30' Chain Catch (Revision B) Page 1 of 2

Assembly Update AU038

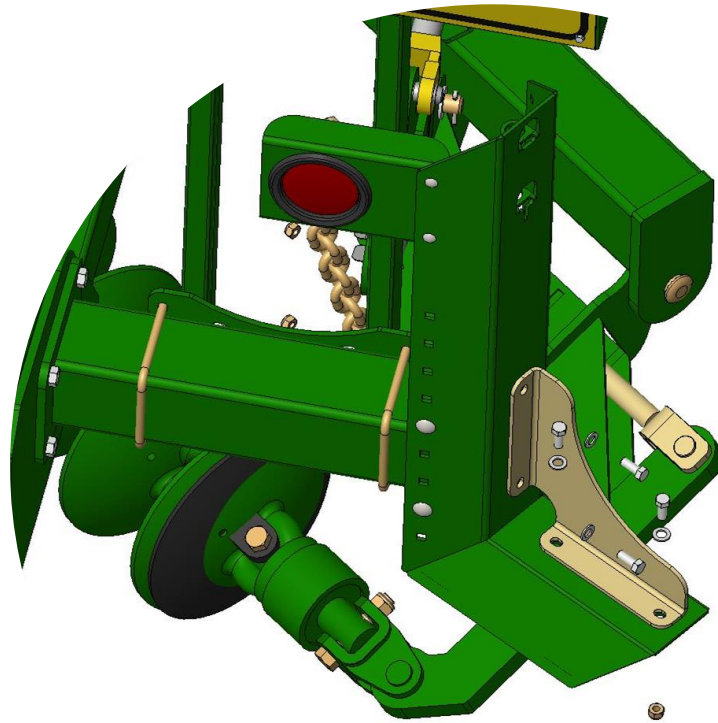
It has come to our attention that in some circumstances the right hand rear chain on the 30' machine has come off of the chain carrier end while in transport. To minimize this we have put a chain catch in place to resolve this issue. Please note that all chain carriers will have holes in them but it is only the rear two that need the catch.

New kit will include,

2x0800-360 plate

8xM12x8.8x30mm ZP Bolts (0211-1230)

8xM12 Flat washers (0231-F12)

8xM12 Nyloc Nuts (0221-NYL12)
